UNITED STATES PATENT AND TRADEMARK OFFICE

10/043,329

Office Action Summary	Application No. 10/043,329	Applicant(s) BAEK ET AL.	
	Examiner Steven H. Rao	Art Unit 2814

With respect to claim 1 Baluswamy describes an overlay key /comprising:

FIG. 14

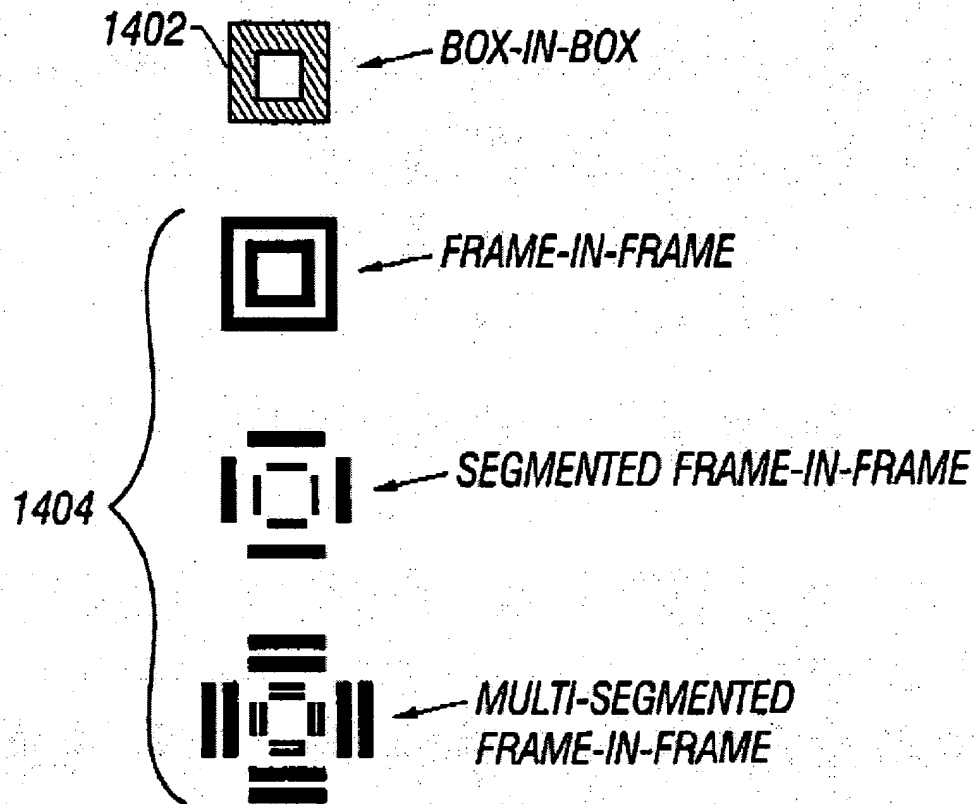
Applicants' arguments with respect to claims 14,18 and 21 that Smith figure 14 does not appear to show a length of first main overlay pattern is equal to a length of a corresponding side of the second main overlay pattern is at odds with figure 14 reproduced below – see especially the multi segmented frame-in-frame wherein first and second pattern are identical forming a square.

Therefore claims 14,18 and 21 are not patentable over the prior art.
